MIL-M-38510/70B
AMENDMENT 2
19 November 1992
SUPERSEDING
AMENDMENT 1
5 November 1987

MICROCIRCUITS, DIGITAL, BIPOLAR, SCHOTTKY TTL,
NAND GATES, MONOLITHIC SILICON

This amendment forms a part of MIL-M-38510/70B, dated 22 November 1985, and is approved for use by all Departments and Agencies of the Department of Defense.

Device type 01

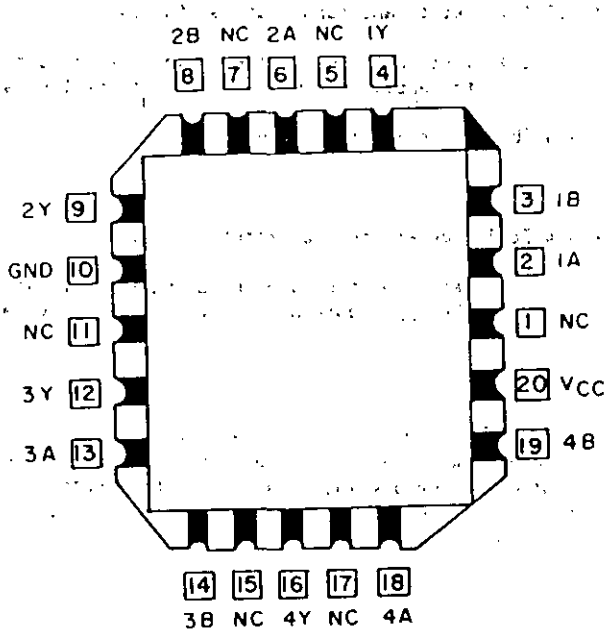
1.2.3, add the following new case outlines:

"2	C-2 (20-terminal, .350" x .350"), square chip carrier package
X	C-2A (20-terminal, .350" x .350"), square chip carrier package"

TABLE III, device type 01, terminal designations, delete and substitute as follows:

Cases														
2,X 2/	2	3	4	6	8	9	10	12	13	14	16	18	19	20
A,B,C,D	1	2	3	4	5	6	7	8	9	10	11	12	13	14
	1A	1B	1Y	2A	2B	2Y	GND	3Y	3A.	3B	4Y	4A	4B	V_{CC}

TABLE III, device type 01, terminal designations, delete and substitute as follows:

Cases														
2,X 2/	2	3	4	6	8	9	10	12	13	14	16	18	19	20
A,B,C,D	1	2	3	4	5	6	7	8	9	10	11	12	13	14
	1A	1B	1Y	2A	2B	2Y	GND	3Y	3A	3B	4Y	4A	4B	V_{CC}

Device type 03

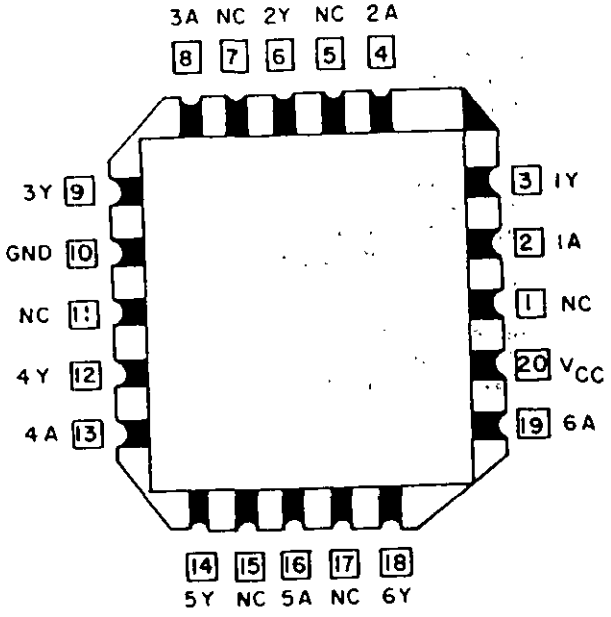
TABLE III, device type 03, terminal designations, delete and substitute as follows:

Cases														
2,X 2/	2	3	4	6	8	9	10	12	13	14	16	18	19	20
A,B,C,D	1	2	3	4	5	6	7	8	9	10	11	12	13	14
	1A	1Y	2A	2Y	3A	3Y	GND	4Y	4A	5Y	5A	6Y	6A	V_{CC}

TABLE III, device type 03, terminal designations, delete and substitute as follows:

Cases														
2,X 2/	2	3	4	6	8	9	10	12	13	14	16	18	19	20
A,B,C,D	1	2	3	4	5	6	7	8	9	10	11	12	13	14
	1A	1Y	2A	2Y	3A	3Y	GND	4Y	4A	5Y	5A	6Y	6A	V_{CC}

Device type 05

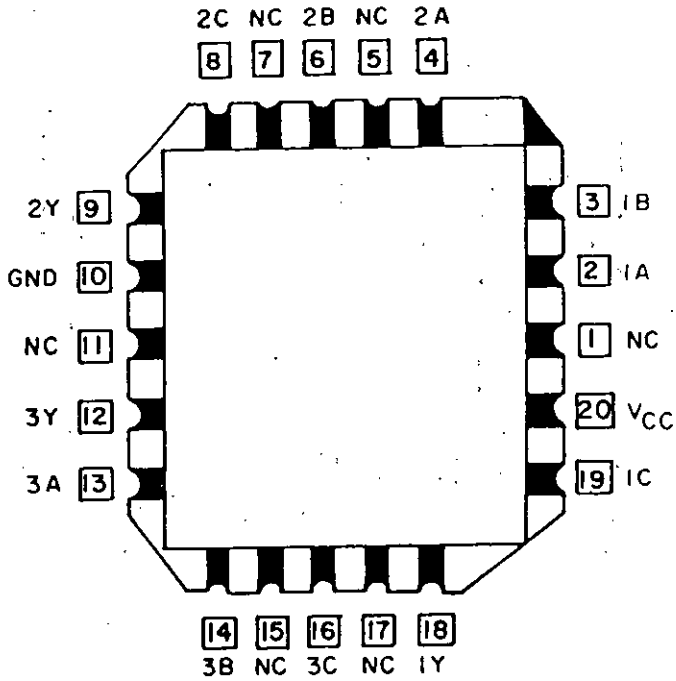
TABLE III, device type 05, terminal designations, delete and substitute as follows:

Cases														
2,X 2/	2	3	4	6	8	9	10	12	13	14	16	18	19	20
A,B,C,D	1	2	3	4	5	6	7	8	9	10	11	12	13	14
	1A	1B	2A	2B	2C	2Y	GND	3Y	3A	3B	3C	1Y	1C	V_{CC}

TABLE III, device type 05, terminal designations, delete and substitute as follows:

Cases														
2,X 2/	2	3	4	6	8	9	10	12	13	14	16	18	19	20
A,B,C,D	1	2	3	4	5	6	7	8	9	10	11	12	13	14
	1A	1B	2A	2B	2C	2Y	GND	3Y	3A	3B	3C	1Y	1C	V_{CC}

Device type 06

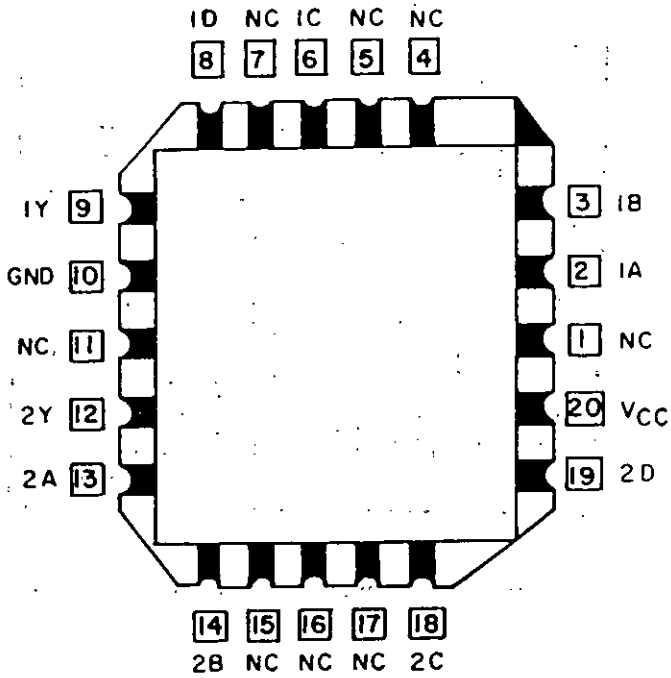
TABLE III, device type 06, terminal designations, delete and substitute as follows:

Cases														
2,X 2/	2	3		6	8	9	10	12	13	14		18	19	20
A,B,C,D	1	2	3	4	5	6	7	8	9	10	11	12	13	14
	1A	1B	NC	1C	1D	1Y	GND	2Y	2A	2B	NC	2C	2D	V_{CC}

TABLE III, device type 06, terminal designations, delete and substitute as follows:

Cases														
2,X 2/	2	3		6	8	9	10	12	13	14		18	19	20
A,B,C,D	1	2	3	4	5	6	7	8	9	10	11	12	13	14
	1A	1B	NC	1C	1D	1Y	GND	2Y	2A	2B	NC	2C	2D	V_{CC}

Device type 09

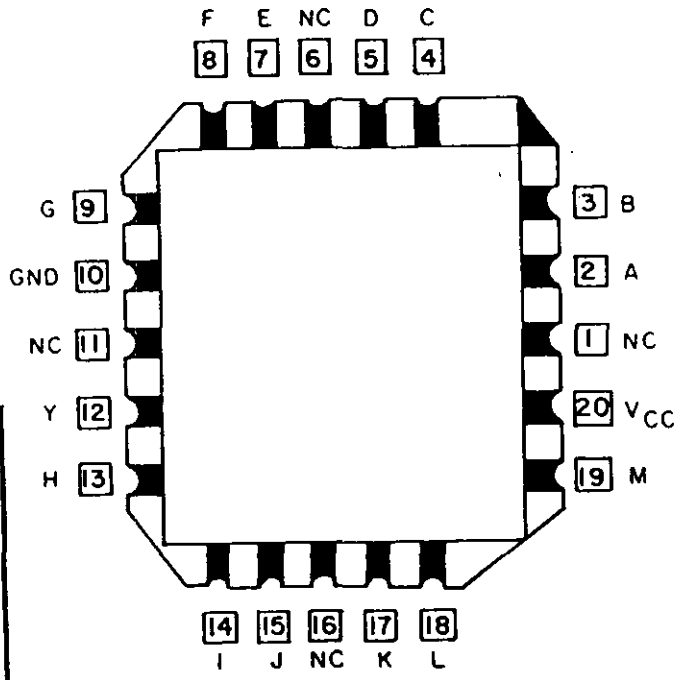
TABLE III, device type 09, terminal designations, delete and substitute as follows:

Cases																
2,X 2/	2	3	4	5	7	8	9	10	12	13	14	15	17	18	19	20
E,F	1	2	3	4	5	6	7	8	9	10	11	12	13	14	15	16
	A	B	C	D	E	F	G	GND	Y	H	I	J	K	L	M	V_{CC}

TABLE III, device type 09, terminal designations, delete and substitute as follows:

Cases																
2,X 2/	2	3	4	5	7	8	9	10	12	13	14	15	17	18	19	20
E,F	1	2	3	4	5	6	7	8	9	10	11	12	13	14	15	16
	A	B	C	D	E	F	G	GND	Y	H	I	J	K	L	M	V_{CC}

TABLE III, device type 09, terminal designations, delete and substitute as follows:

Cases																
2,X 2/	2	3	4	5	7	8	9	10	12	13	14	15	17	18	19	20
E,F	1	2	3	4	5	6	7	8	9	10	11	12	13	14	15	16
	A	B	C	D	E	F	G	GND	Y	H	I	J	K	L	M	V_{CC}
